Project : MT6765 LPDDR3

REF_SCH TOP LEVEL

Rev	13_BB_2
Size	A1
MTK Confidential

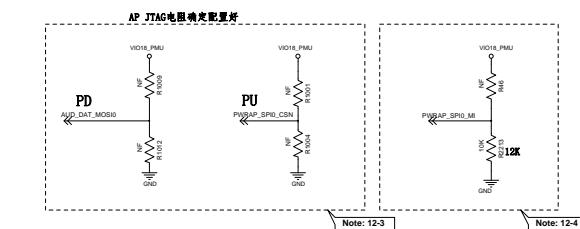
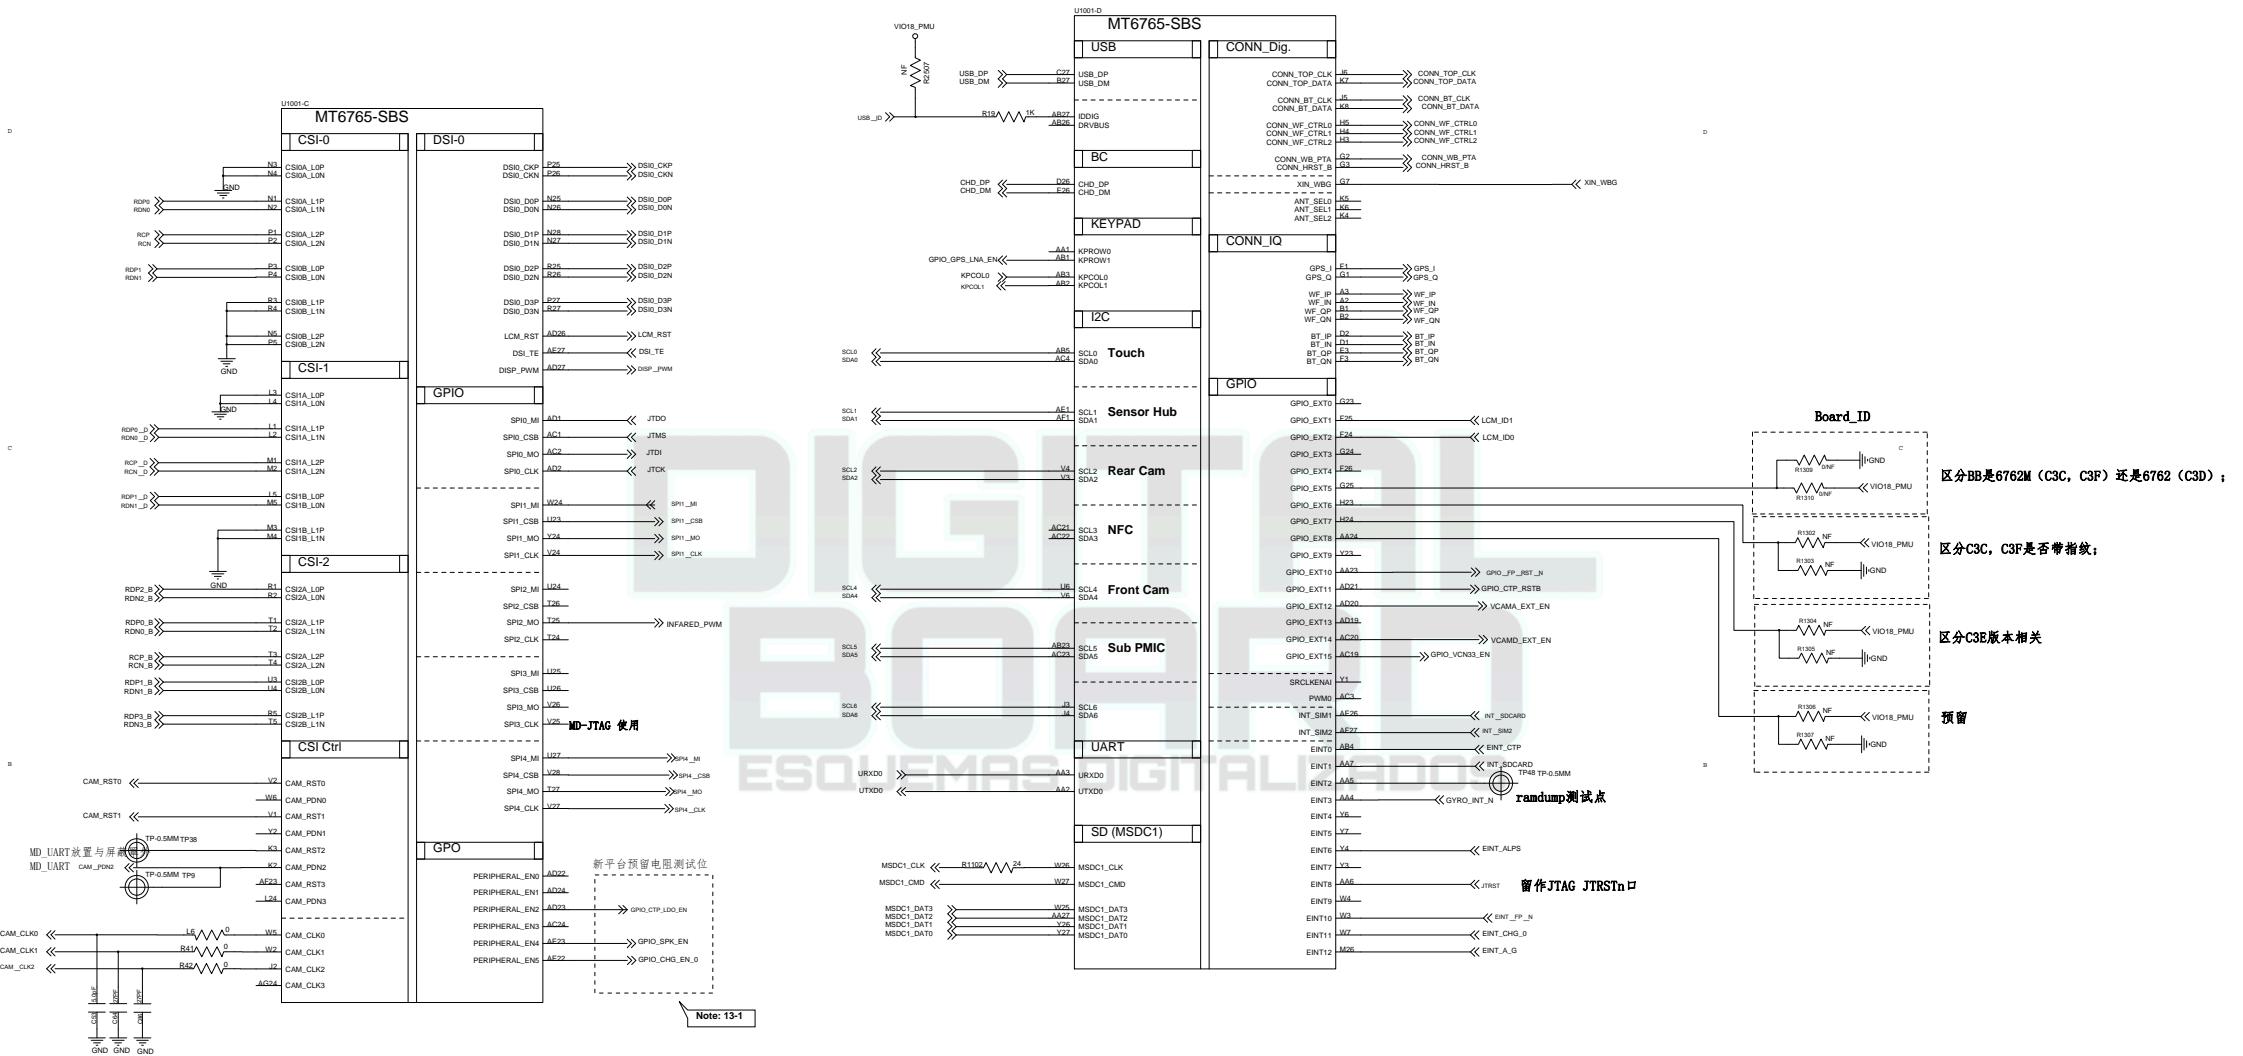
注释错误

Main Camera

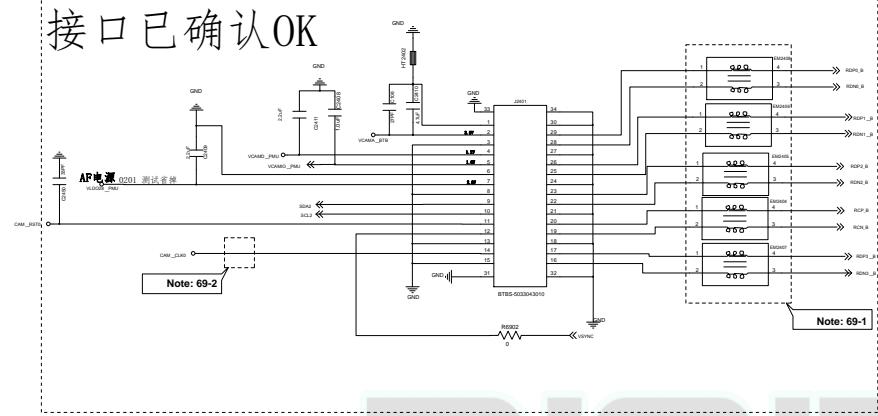
接口已确认OK

FRONT_camera

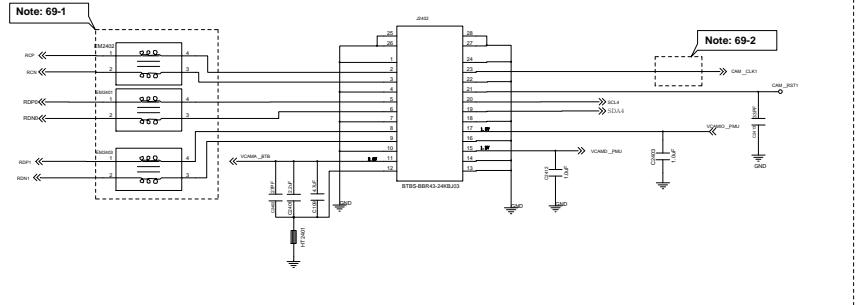
增加双摄

接口已确认OK

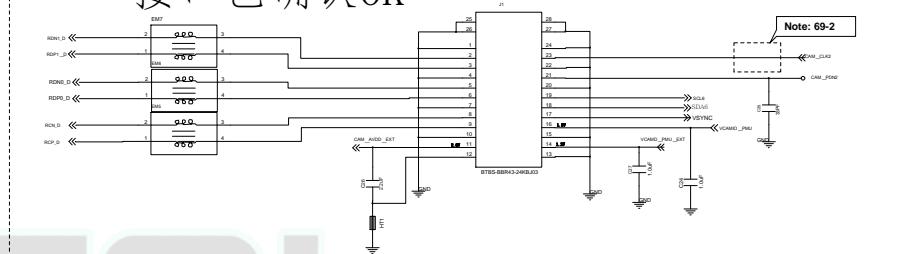
注意信号连接,I2C,CLK等的选用

AVDD, DVDD需要单独增加LDO

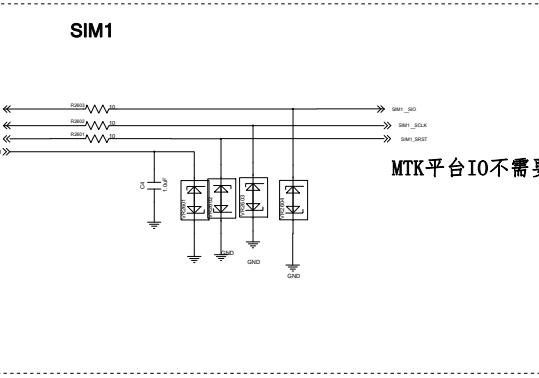
MTK平台IO不需要上拉

SIM2

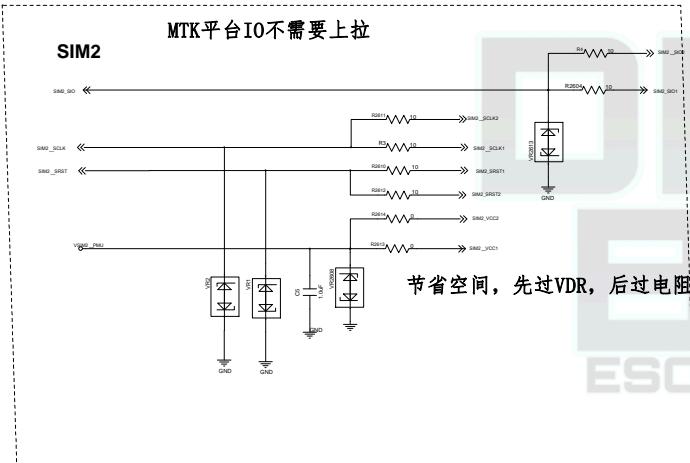
MTK平台IO不需要上拉

节省空间，先过VDR，后过电阻

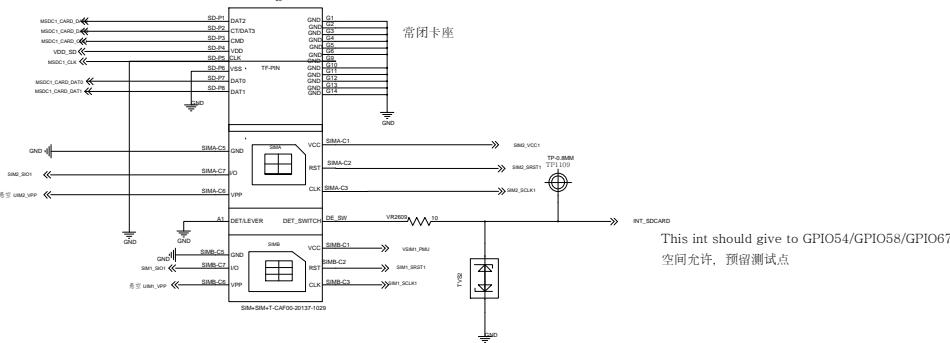
空间允许，预留测试点

Power Key / Key Pad

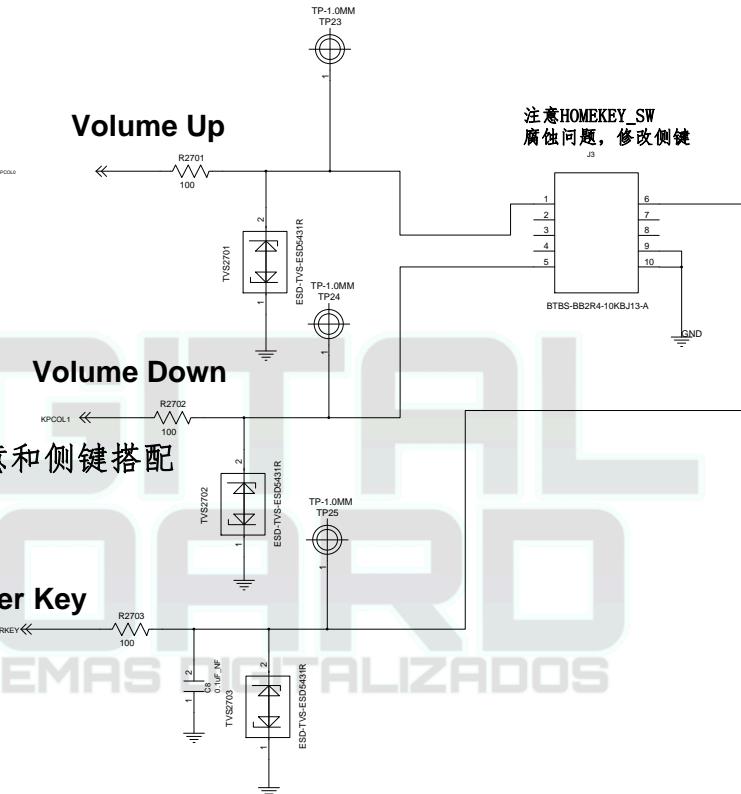
RAMDUMP debug key 省掉? ?
